PCN-20210615 TE0820-04 eMMC Change and Product Update

Company	Trenz Electronic GmbH
PCN Number	PCN-20210615
Title	TE0820-04 eMMC Change and Product Update
Subject	BOM change
Issue Date	2021-07-22

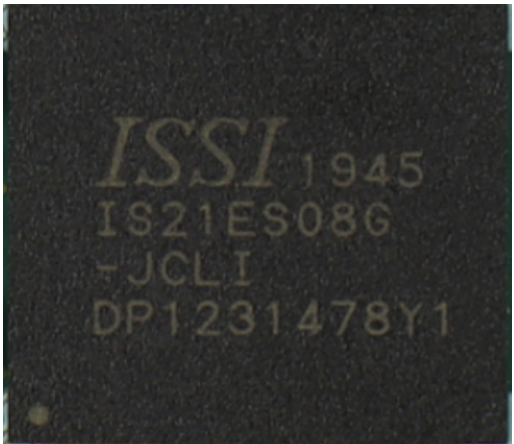
#3 Change Ferrite Beads (L1, L2, L3, L4, L5, L7, L9, L10, L11, L12) BKP0603HS121-T to MPZ0603S121HT000

Reason: Part is NRND and EOL announced.

Impact: None. DC resistance decreased from 150mOhm to 130mOhm, rated current increased from 0.85A to 1A.
